Technical Service Bulletin

No.JTB00117

Subject/Concern:	Transmission Rattle, Difficult Gear Change, Clutch Smell/Smoke or Unable to Select a Gear
-------------------------	---

Models:		
X-TYPE	Manual Gasoline Only	Manual Gasoline Only VIN-range: J43823-J49617
X-TYPE	Diesel 2.0L Manual Only	Diesel 2.0L Manual Only VIN-range: J33194-J49617
X-TYPE	Diesel 2.2L Manual Only	Diesel 2.2L Manual Only VIN-range: J33211-J49617
X-TYPE	Diesel 2.2L Manual with Diesel Particulate Filter (DPF) Only	Diesel 2.2L Manual with Diesel Particulate Filter (DPF) Only VIN-range: J33682-J49617

E107499

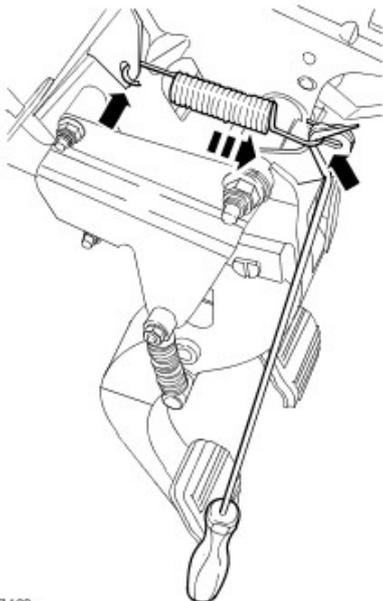
- 5 . **NOTE:** A suitable tool ('Snap On' A1710 or similar) will be required to aid with the installation of the new spring to the clutch pedal. The tool should be long enough to be used by both hands to generate enough force to expand the spring.

Install one end of the new spring to the clutch pedal housing bracket. Install the other end of the new spring to the clutch pedal bracket (see illustration E107499).
